Request for Additional Information
Model No. Traveller
Docket No. 71-9297

By application dated April 1, 2004, Westinghouse Electric Company requested a Certificate of Compliance for the Model No. Traveller package. This request identifies additional information needed by the Nuclear Regulatory Commission staff (the staff) in connection with its review of the safety analysis report (SAR). The requested information is listed by chapter number and title in the SAR. NUREG-1609, "Standard Review Plan for Transportation Packages for Radioactive Material," was used for this review. This request describes information needed by the staff for it to complete its review of the SAR and to determine whether the applicant has demonstrated compliance with regulatory requirements.

Figure 2-11.1 Clamshell Top Plates

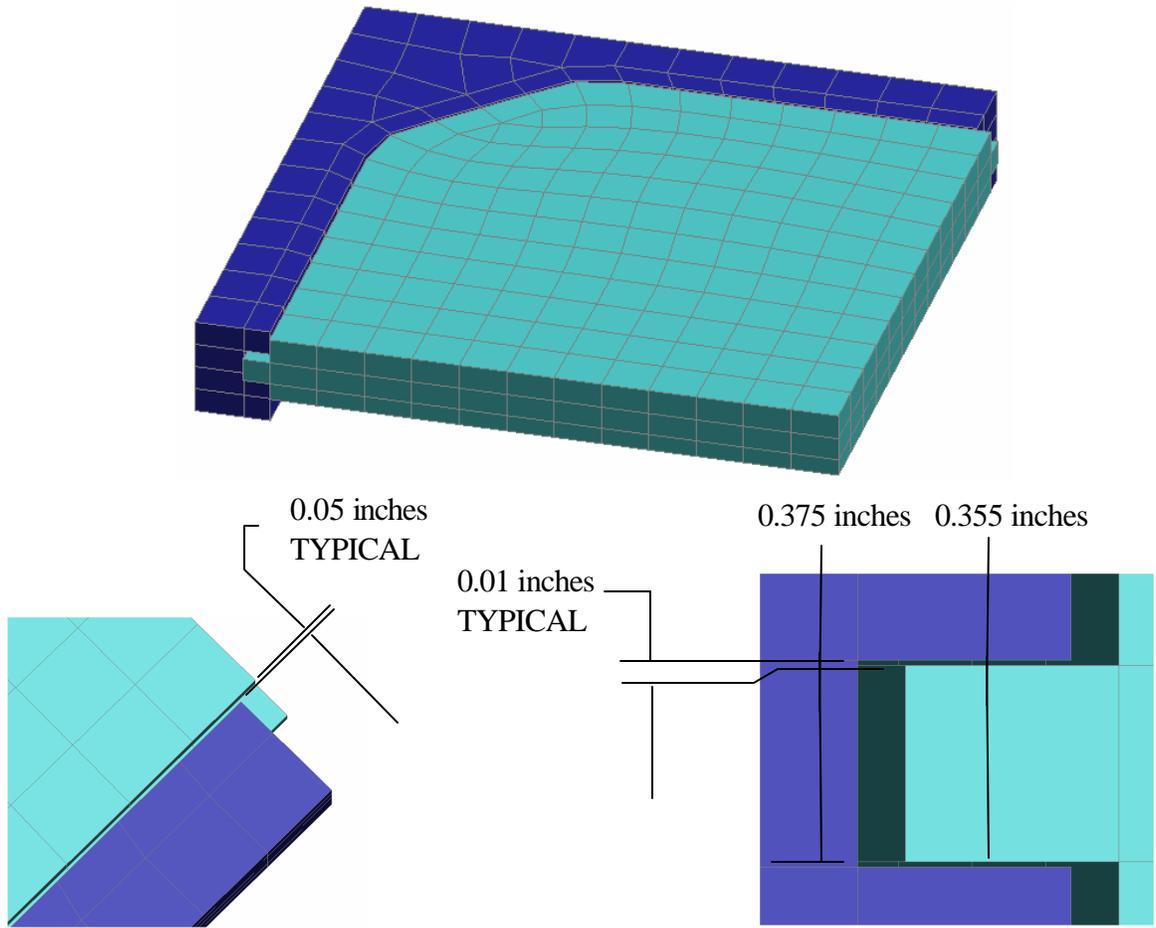
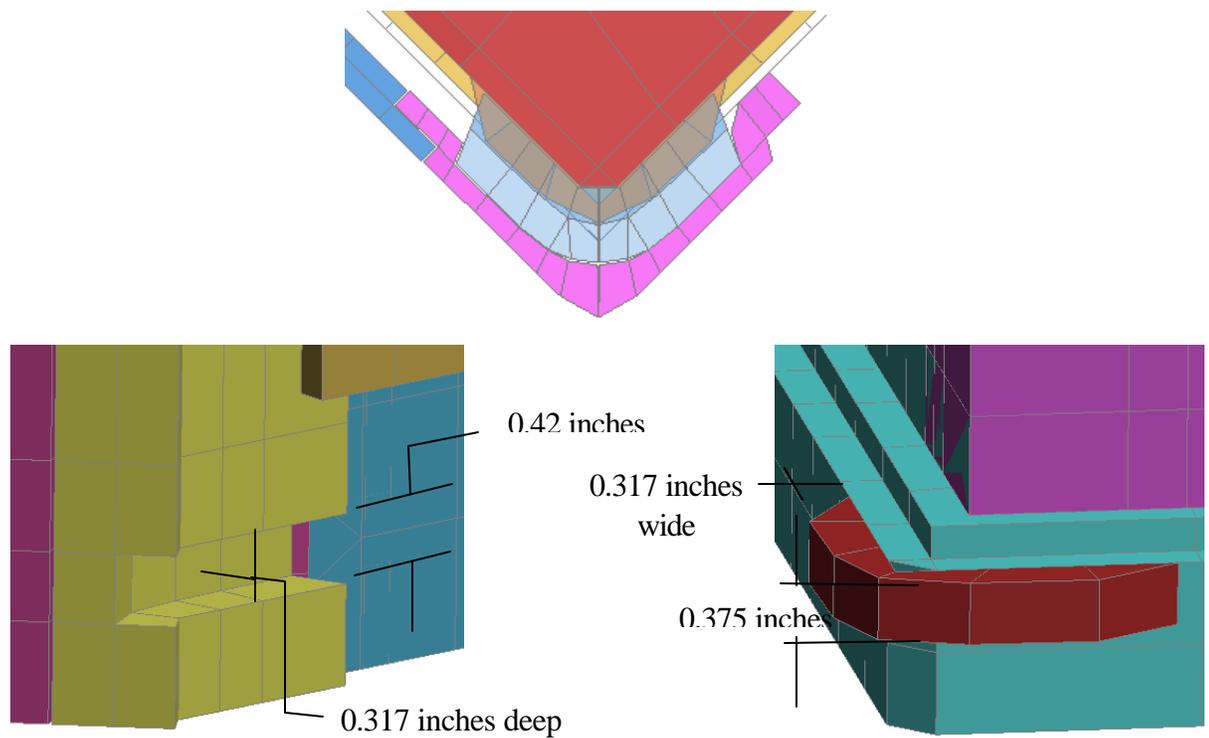
- 2-11 Provide a description of the attributes of and corresponding assumptions for the finite element models for the lipped/grooved interfaces between the Clamshell end plates themselves, at the top end, and between the Clamshell doors and the plate at the bottom end. The application (pages 2-75, 2-84, 2-96) notes that the Clamshell cross-sectional shape is predicted to stay essentially unchanged during the horizontal drops. Because the predicted deformation of the interlocked end joints will depend primarily on the assumptions made for the finite element model, sufficient modeling details, including gap size, and contact stiffness, if any, must be presented for evaluating the analysis results.

The lipped/grooved interface between the clamshell top end plates is shown in Figure 2-11.1 and the interface between the bottom clamshell plate and doors is shown in Figure 2-11.2.

For the top plates, the 0.355 inch thick lip is positioned within a 0.375 inch thick groove, leaving an axial clearance on either side of approximately 0.010 inches. The clearance in the plane of the plates is 0.050 inches. The axial clearance between the lip on the bottom plate and the groove in the latch is 0.0225 inches on both sides (0.42 – 0.375 inches). In the plane of these plates, there is line to line contact since locking the clamshell door involves rotating the latch until the vertical wall in the latch groove contacts the vertical side of the lip extending from the clamshell bottom plate. Contacts were defined using a penalty-based contact algorithm; contact stiffness was found by dividing the nodal mass by the square of the time step size with a scale factor to ensure stability (LS-DYNA's SOFT=1 contact option). Although there is only metal contacting metal in these two situations, this approach was used because the foam has stiffness that is one or more orders of magnitude less than the metal parts. Further, the stiffness of these parts is of similar magnitude and it is most likely the SOFT=1 option did not influence the contact stiffness determined for these parts.

Figure 2-135 QTU Test Series 2 Drop Orientations

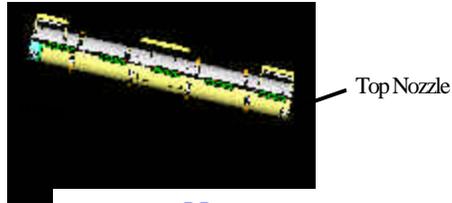
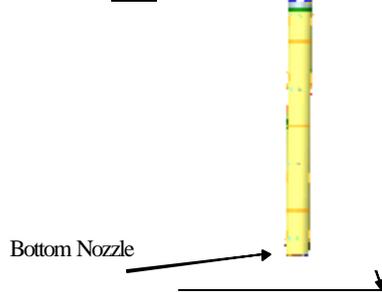
2-14 Correct the following apparent underscored typographical errors, as appropriate:

- Page 2-99, third line from the bottom of the page: “Figure 2-50”
- Page 2-103, fourth line from the top of the page: “Figure 2-41”
- Page 2-104, twelfth line from the bottom of the page: “Figure 2-64”
- Page 2-104, ninth line from the bottom of the page: “Figure 2-82”
- Page 2-104, third line from the bottom of the page: “Figure 2-83”
- Page 2-106, third line from the top of the page: “Figure 2-44”
- Page 2-159, Table 2-32, Item 2.1: “1.2-m NAC drop”
- Page 2-177, Figure 2-135: “Test 2.3”
- Page 2-177, Figure 2-135: “Test 2.4”

- Page 2-99, third line from the bottom of the page: “Figure 2-49”
- Page 2-103, fourth line from the top of the page: “Figure 2-61”
- Page 2-104, twelfth line from the bottom of the page: “Figure 2-44”
- Page 2-104, ninth line from the bottom of the page: “Figure 2-62”
- Page 2-104, third line from the bottom of the page: “Figure 2-63”
- Page 2-106, third line from the top of the page: “Figure 2-64”
- Page 2-159, Table 2-32, Item 2.1: “1.2-m NAC drop” (No correction needed)
(Added reference for Table 2-32 to page 2-158)
- Page 2-177, Figure 2-135: “Test 2.3” (Replaced Figure 2-135)
- Page 2-177, Figure 2-135: “Test 2.4” (Replaced Figure 2-135)

Figure 2-15.1 Shock Mounts in Qualification Unit Model

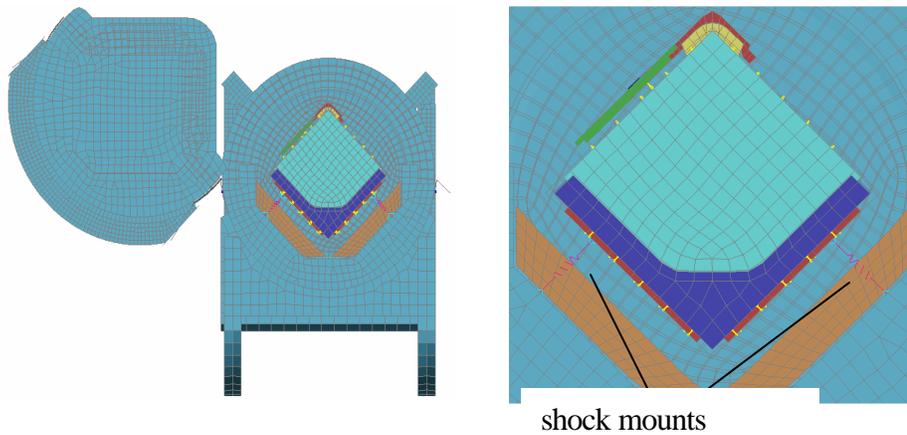
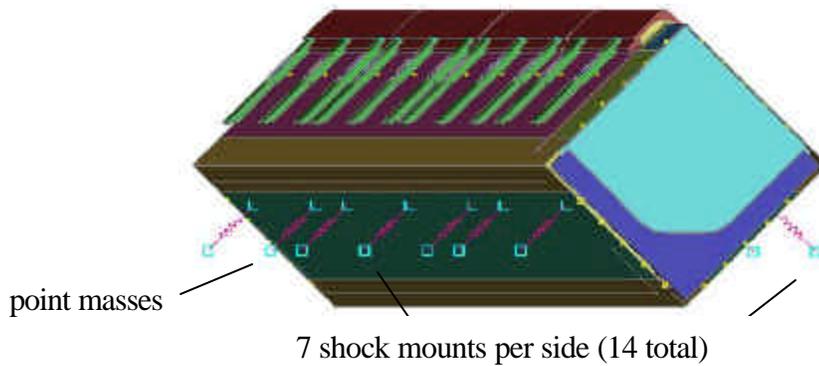
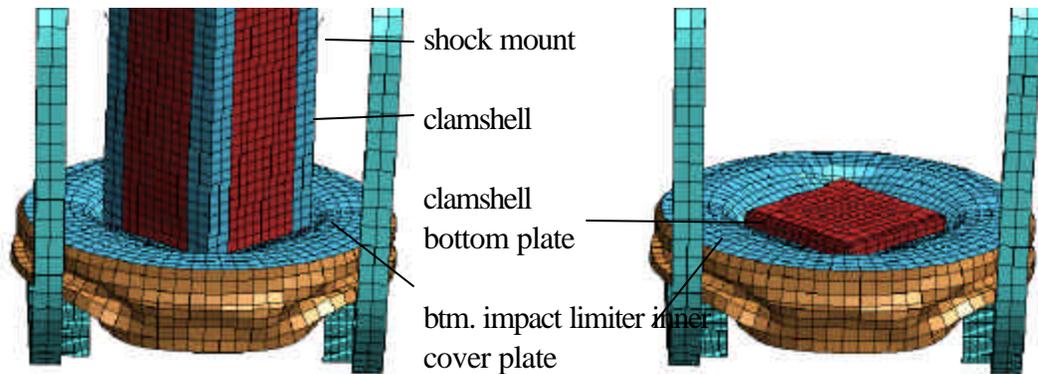
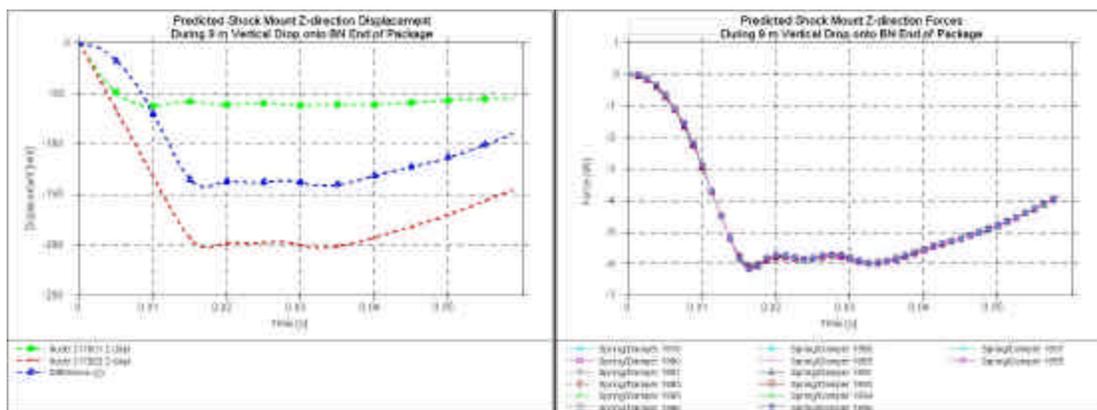
- 2-15 Provide a description of relevant model attributes, including use of sketches, to clarify the statement made on page 2-102, “[t]he vertical load developed by shock mounts is negligible and was ignored.” It is not clear from the information provided how the Clamshell loads and accelerations are defined with respect to the Clamshell shock mounts layout.

The quoted statement in the SAR is incorrect on two counts. First, the loads exerted on the clamshell by the shock mounts are not negligible. Secondly, they were not neglected. Rather the clamshell accelerations stated for the vertical drops 605 and 843 kN (Section 2.12.3.2.5 and Figure 2-57) loads are actually lower due to the loads exerted on the clamshell by the shock mounts. This is explained below.

The loads on the clamshell due to the shock mount extension are calculated using $F=k\delta$. For the vertical case, the spring constant, k , is 42.3 N/mm. Further, the shock mount extension, δ , is the difference in the z deflection of the end nodes of the shock mounts (Figure 2-15.4). Finally, the total vertical force on the clamshell from the 14 shock mounts is summed from the 14 individual contributions. Thus, the maximum z-direction force exerted on the clamshell by the 14 shock mounts was approximately 85.4 kN (6.1 kN x 14). Further this load level was maintained from 0.016 to 0.033 seconds after initial impact.

Figure 2-63A Predicted Temperature and Foam Density Effect on Outerpack/Drop Pad Interface Forces (9m Vertical Drop onto the Bottom End of the Package)

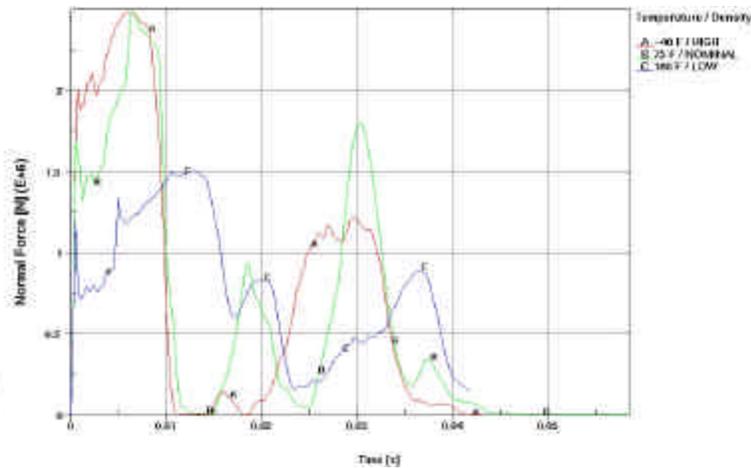
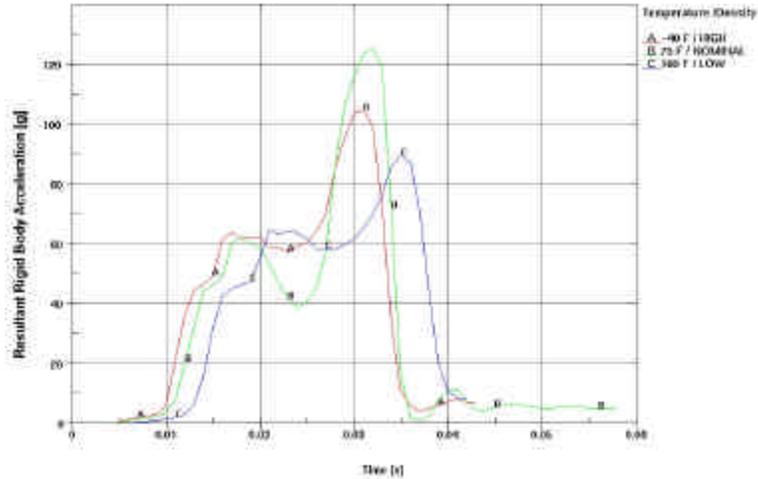
- 2-16 Revise Section 2.12.3.2.6 to include a reevaluation of effects of temperature and foam density change on the drop test performance of the Traveller package, considering a 9-meter bottom-end down drop test.

Temperature/foam tolerance effects for the 9 meter vertical drop onto the bottom nozzle end of the package were evaluated for the three previously noted conditions. Both predicted outerpack/drop pad force histories and fuel assembly accelerations were compared as shown in Figures 2-63A and 2-63B.

Both of these figures predict that the highest forces occur when the package is 24°C (75°F) with the package having nominal foam density. (This does not necessarily mean that a package dropped at 24°C/75°F having foam densities at either the high or low end of the tolerance band would have had lower outerpack/drop pad forces and lower FA accelerations since that was not investigated.) In particular, the predicted maximum outerpack load for the 75°F (24°C)/nominal foam density scenario was 2.5E6 N. This was equal to that predicted for -40°C (-40°F) with foam density at the upper end of the tolerance band and about 67% greater than the 1.5E6 N load predicted for 71°C (160°F) with foam density at the lower end of the tolerance band. Moreover, a maximum FA acceleration of 126 g's was predicted for drops at 24°C (75°F) with the package having nominal foam density. This was approximately 20% higher than the 105 g's predicted for the -40°C (-40°F) with foam density at the upper end of the tolerance band scenario and approximately 40% higher than the 90.1 g's predicted for 71°C (160°F) with foam density at the lower end of the tolerance band case.

Figure 2-91 Predicted and Measured Y Accelerations

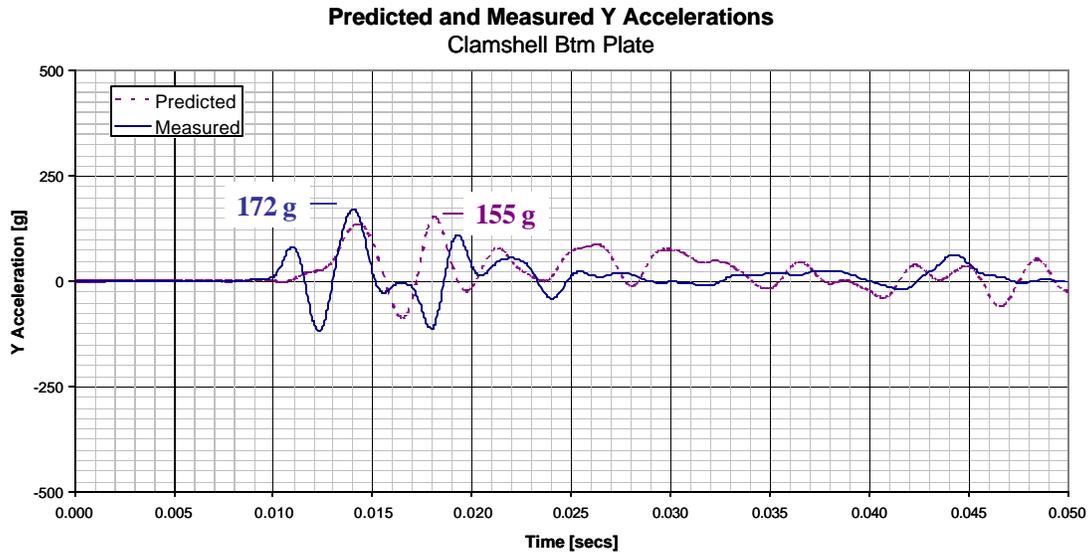
- 2-17 Verify annotation for the measured “Y - Axial g-force” for Figures 2-89 and 2-119. Annotations for the drop response traces are confusing. Throughout the application, the Y coordinate appears to have been assigned to “Vertical,” in lieu of “Axial,” responses such as that of “Y - Vertical g-force” of Figure 2-118.

No change was required to the text of the SAR. Figure 2-91 was replaced.

The container coordinate axes are defined in Figure 2-103 of the SAR and perhaps better illustrated in Figure 2-23. As shown in these figures, the Z-axis is the axial coordinate and is positively directed going from the BN end to the TN end of the package; the Y-axis is perpendicular to the ground and directed upwards when the package is resting on its legs; and the X-axis, defined by the right-hand rule, goes through the plane of the lower and upper overpack mating surfaces. The accelerometers are fixed to the container and the accelerometer axes were aligned with the container axes.

Figure 2-117A Accelerometer Locations on Prototype Drop Test

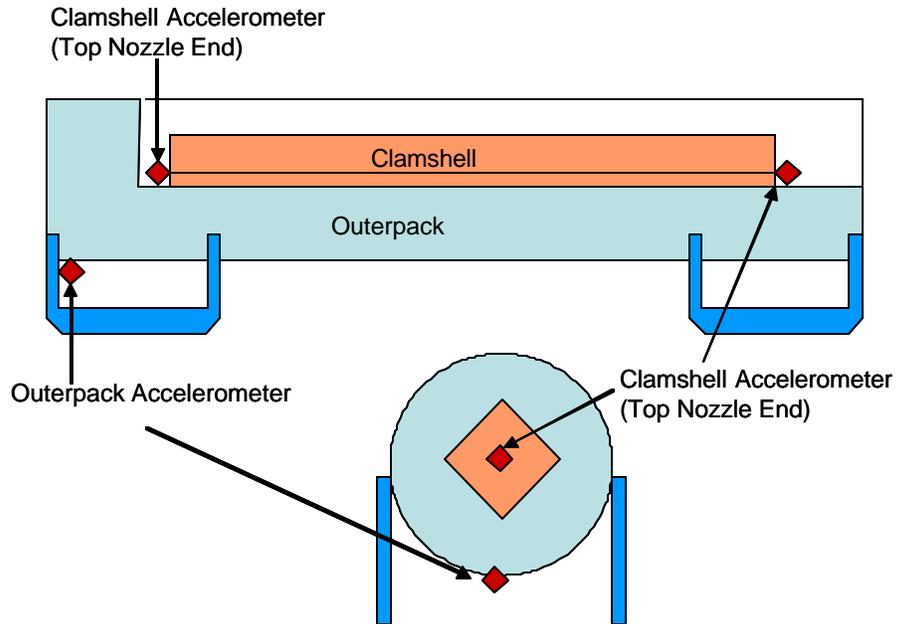
- 2-18 Provide sketches depicting the accelerometer installation plan for the drop tests. The application should include accelerometer locations on the test articles to evaluate correlation between the measured and predicted results.

The locations of these accelerometers are shown in Figure 2-117A.

Figure 2-108 Stress-Strain Characteristics of Aluminum in Clamshell

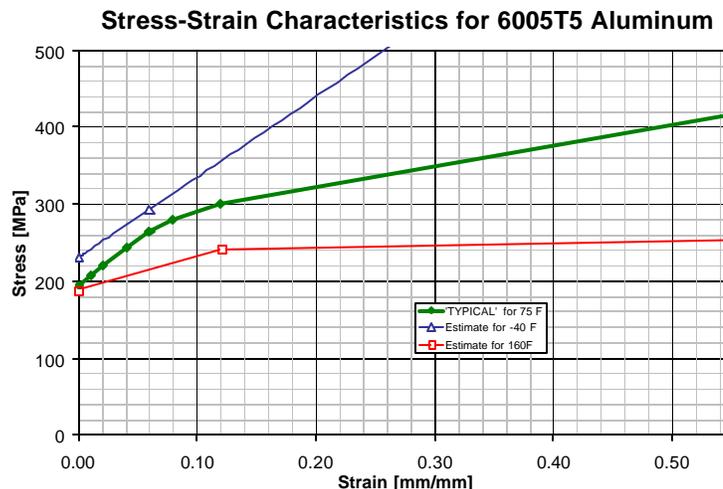
- 2-21 Verify the temperature-dependence stress-strain curve plots, Figure 2-108, for the Clamshell aluminum at 160° F and -40° F. The stress-strain curves at the two temperatures appear to have been mislabeled.

The following figure, Figure 2-108 has been replaced:

Figure 2-105A Foam Response at Strains from 0-10%

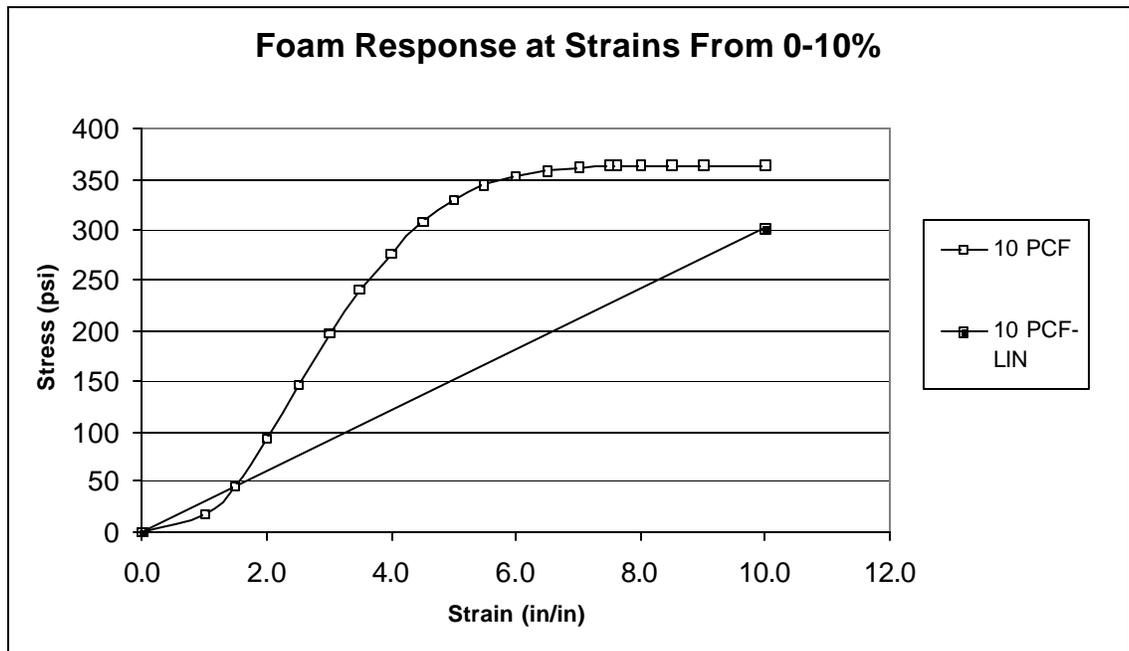
- 2-22 Revise Figure 2-105, as appropriate, to provide detailed stress-strain data for the strains ranging from zero to ten percent. Also, re-evaluate the bottom end drop to determine effects

of cold temperature on package structural performance by using relevant stress-strain data in the finite element analysis. The staff notes that there are no stress-strain data reported for the strain range cited above. By assigning a yield point at the 10-percent strain offset, which had not been substantiated, the result was an assumption on the rate of momentum change of the free dropping package to dictate certain analysis outcomes.

The use of a linear elastic material model from 0-10% strain was selected to evaluate the effects of temperature and foam density on drop test reaction forces. From Section 2.12.3.2.6, foam linear data demonstrated that temperature and foam density have a minor effect on the drop test response of the Traveller. The use of true stress-strain data ranging from 0-10% would not impact the conclusions of the comparative analysis.

A typical comparison of foam stress-strain behavior demonstrates that the available strain energy of a linear model is less than that observed with true stress-strain data. The use of true stress-strain data is expected to result in greater foam deflection when compared to linear modeling. Since greater crushing would absorb more kinetic energy, the predicted reaction force of the outerpack using true stress-strain data is expected to be less compared to linear data. It is concluded that the use of linear stress-strain data in the 0-10% range adds additional conservatism to the model.

Figure 2-23 Bolt FE Models

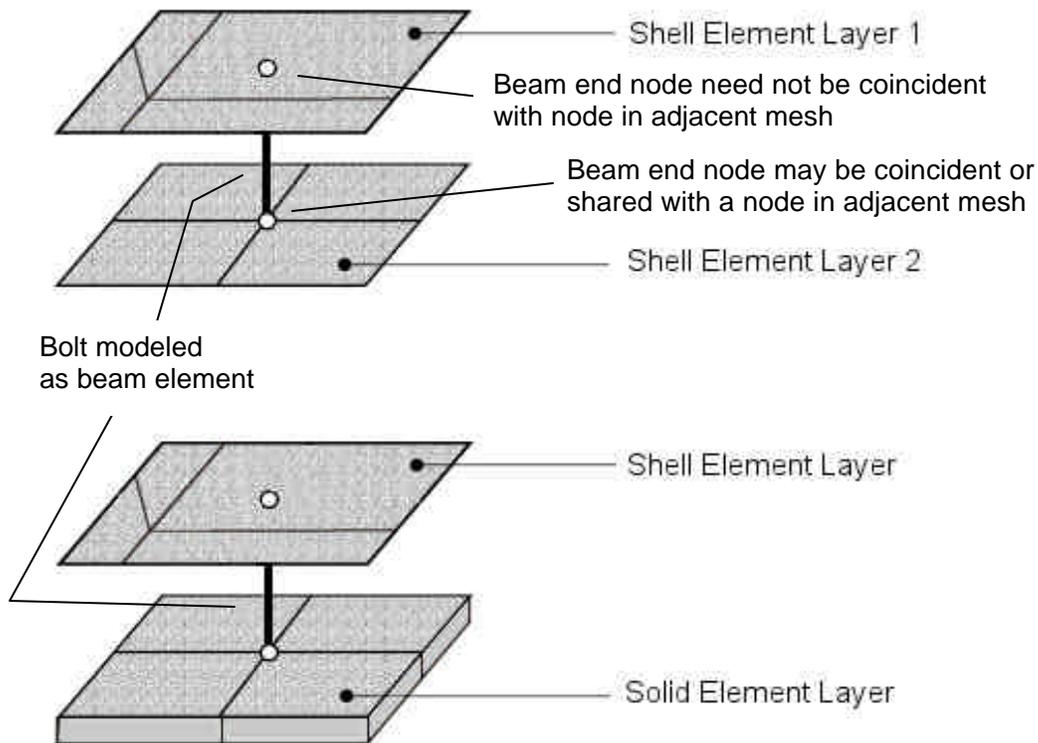
2-23 Provide a description of the finite element models used for calculating bolt axial and shear forces, Table 2-26. For the resulting forces, justify the basis for using the ultimate strengths in the interaction equation evaluation of factors of safety for the bolts subject to concurrent tensile and bi-axial shear forces. It is not clear from the information provided whether the bolts were allowed to yield in the finite element analysis of the drop accident, which could markedly affect the calculated bolt forces. The staff notes that bolt interaction equations generally do not lend themselves to an evaluation involving material ultimate strengths.

A schematic of the finite element bolt model is shown in Figure 2-23. This is representative of all bolts used in the shipping package. It consists of a 3D beam element whose end nodes are in the plane of the layers being joined by the bolt. The end nodes are attached to the shell or solid elements either by being shared or by being tied using a penalty-based constraint.

Bolt material was modeled as steel with isotropic hardening. Thus, the bolts are indeed allowed to yield and still function until the criteria shown in the bolt interaction equation (equation H-2 in

Figure 2-95 Impact Limiter in Prototype Unit Model

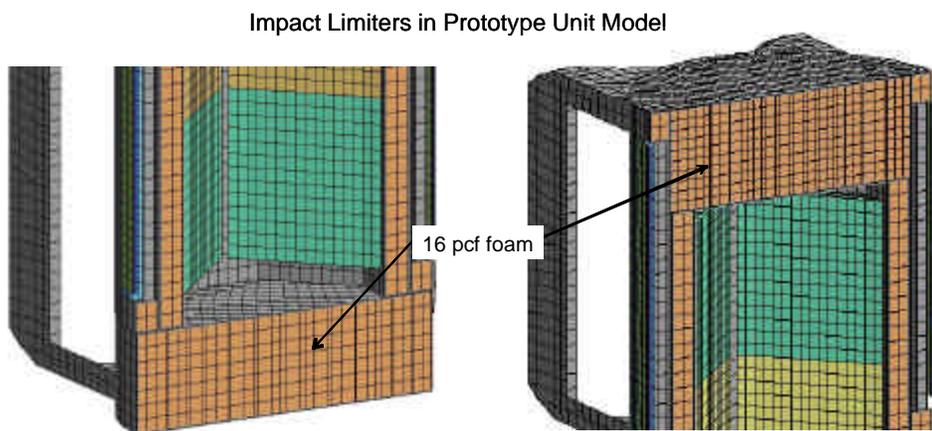
- 2-25 Provide a discussion clarifying the apparent discrepancy between the statement provided on page 2-148, “[t]he prototype packages employed 11 pcf foam along the axial section of the package and 16 pcf foam in the endcaps,” and the information provided in Figures 2-95 and 2-112 which indicate that the end cap for the Prototype Test Unit was filled with the 11 pcf, rather than the 16 pcf, foam.

The following figure, Figure 2-95, has been replaced:
